FARRAGUT VISUAL RESOURCES REVIEW BOARD AGENDA

Tuesday, March 23, 2021
7:00 p.m.

TO: Farragut Visual Resources Review Board
FROM: Bart Hose, Assist. Community Development Director.
SUBJECT: Regularly Scheduled Meeting - Tuesday, March 23, 2021 at 7:00 p.m.

S03

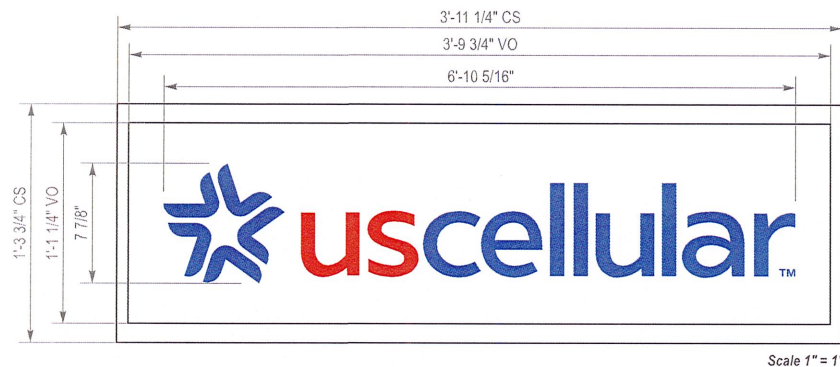
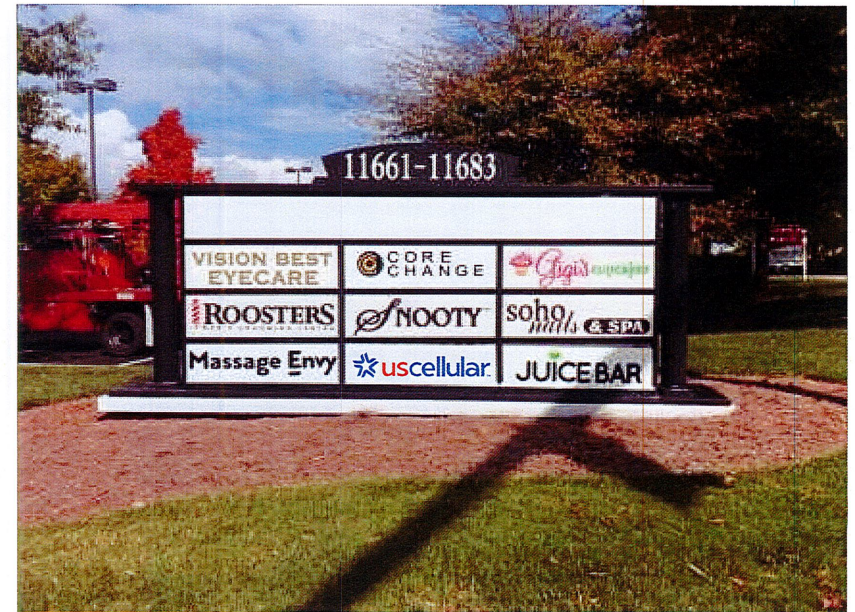
Staff contacted the applicants and suggested they utilize darker shades of blue and red for the lettering, and/or a larger font to improve readability, but no action was taken. The tenant panel does, however, appear to be legible and the staff can recommend approval.

3 **1** MONUMENT REFACE **40.0 sf**
 SCALE: 3/4"=1"
 (2) REQ'D

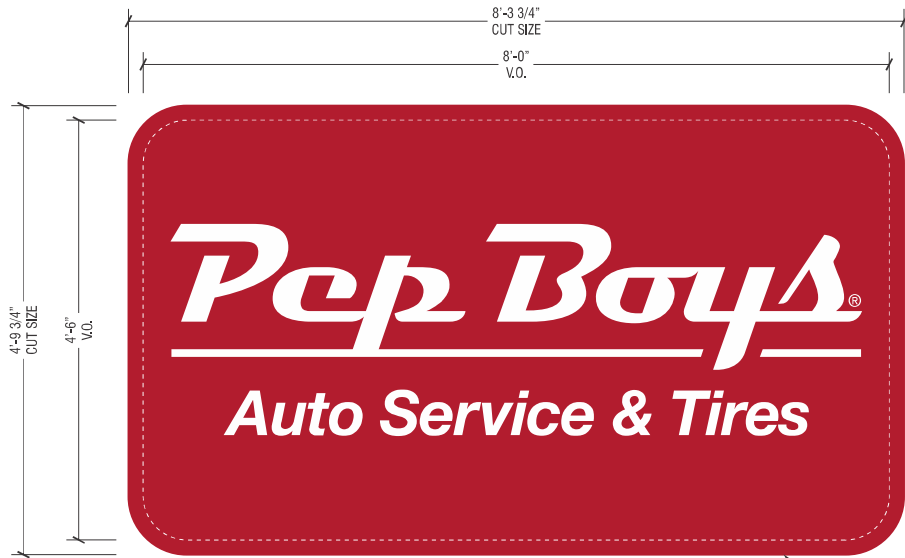
Pep Boy's is requesting approval for a monument ground sign located at 10839. The request involves refacing and making improvements to an existing sign structure on the site. The applicants are adding a brick base to the existing sign structure, but because of the way it was originally constructed, they cannot achieve a full two feet of base height. They will also be reestablishing the required landscaping around the sign.

Given the existing nature of the sign structure, the staff recommends approval of the new sign face and other improvements.

L101

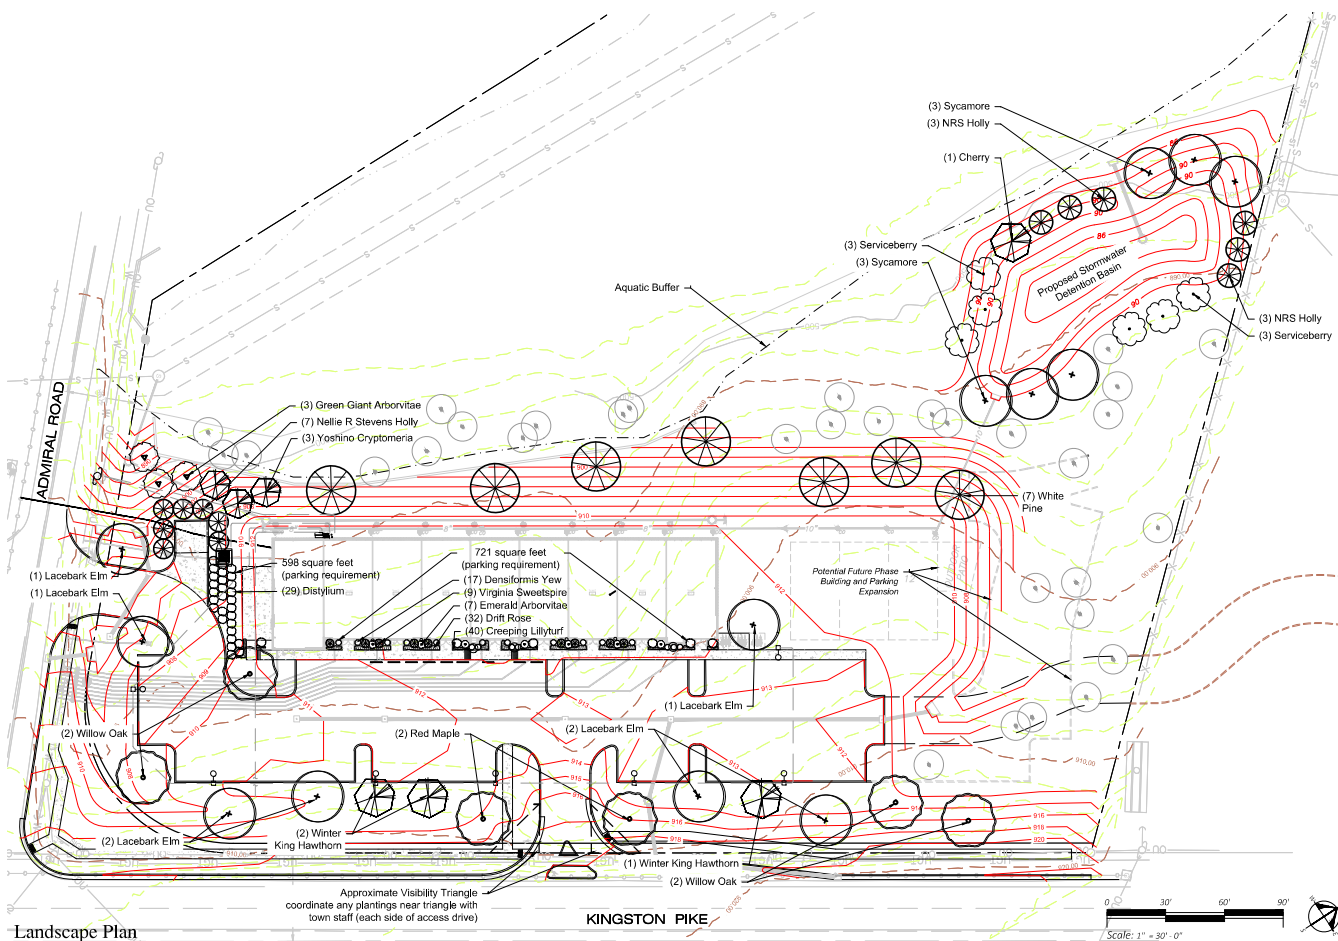
1. Correcting the Tree Replacement/Credit calculations;

2. Adding one additional flowering tree variety to the stormwater basin area;
3. Replacing the Creeping Lillyturf (*Liriope spicata*) with a non-invasive alternative; and
4. Adjusting tree locations and/or species to better account for the overhead power lines and easement areas along the road frontages.

The staff recommends approval of the plan subject to:

The applicant is in the process of addressing these issues.
